The ISO received comments on the topics discussed at the November 16, 2018 stakeholder meeting from the following:

Copies of the comments submitted are located on the 2018-2019 Transmission Planning Process page at:
<http://www.caiso.com/planning/Pages/TransmissionPlanning/2018-2019TransmissionPlanningProcess.aspx>

The following are the ISO's responses to the comments.

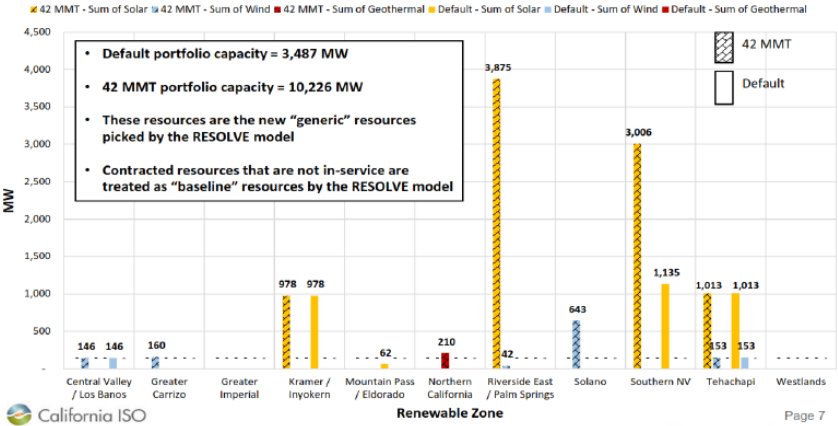
No	Comment Submitted	CAISO Response
2b	<p><u>Policy Assessment</u></p> <p>The CPUC Integrated Resource Plan (IRP) 42 MMT Scenario portfolio and the CPUC IRP Reference System Plan were studied as a sensitivity in the 2018-2019 TPP policy-driven assessment to identify potential Category 2 informational transmission projects. The study found that while Full Capacity Deliverability Status (FCDS) resources are deliverable based on the CAISO new proposed Deliverability calculation methodology, higher curtailment of renewable generation could result. The finding supports the previously noted need for a greater understanding of the proposed Deliverability calculation methodology and how impacted parties can understand the potential for curtailment, the process for how such curtailment is quantified and, if economically justified, how mitigation will take place in a timely manner.</p> <p>As we had indicated in our prior comments in the 2018-2019 TPP, we have some serious concerns about the sufficiency of the feedback loop concerning transmission constraint information between the CAISO reliability and deliverability assessment and the CPUC's renewable portfolios. In those comments, we had provided an example that demonstrated a need to establish a more effective and timely feedback loop within the same cycle to avoid potential approval of an unneeded policy-driven transmission project.</p> <p>In Figure 1 below, we suggest a timeline for CAISO's consideration entailing an exchange of data and information among CAISO TPP, CPUC IRP, and involved stakeholders. In particular, we request the CAISO to provide its draft transmission capability estimates to the CPUC's IRP comprising the stakeholder feedback in mid-December 2018. This would allow the CPUC adequate time to include those estimates in the RESOLVE model and provide the resulting draft "Conforming Hybrid" resource portfolio - to be used in the 2019-2020 reliability and policy-driven assessment - to the CAISO by mid-January 2019.</p>	<p>The ISO must reiterate that the purpose of the deliverability analysis has been limited to ensuring that sufficient transmission is available to provide reasonable assurance that resource adequacy capacity can be delivered to load at times of need. However, the deliverability analysis has resulted in identifying a few policy-driven transmission projects needed for a large amount of renewable generation in situations where the resource adequacy deliverability and policy-driven needs overlapped. Going forward there may be less overlap between these two separate types of needs. The ISO expect some of these issues can be discussed further during the stakeholder consultation the ISO expects to initiate in Q2 regarding the deliverability methodology.</p> <p>The ISO does not agree with the characterization of the circumstances of the example provided in previous comments.</p> <p>The timelines proposed are generally unrealistic given the resource requirements necessary to conduct these studies and other planning activities that either have to precede these studies or run concurrently. In any event, the key information updating the transmission system capabilities come from GIP phase-1 study results, first available in mid-January of each year. Finally, the ISO tariff addressing policy-driven transmission (section 24.4.6.6, Policy-Driven Transmission Solutions) states:</p> <p><i>"Any transmission solutions that are in the baseline scenario and at least a significant percentage of the stress scenarios may be Category 1 transmission solutions. Transmission solutions that are included in the baseline scenario but which are not included in any of the stress scenarios or are included in an insignificant percentage of the stress scenarios, generally will be Category 2 transmission solutions, unless</i></p>
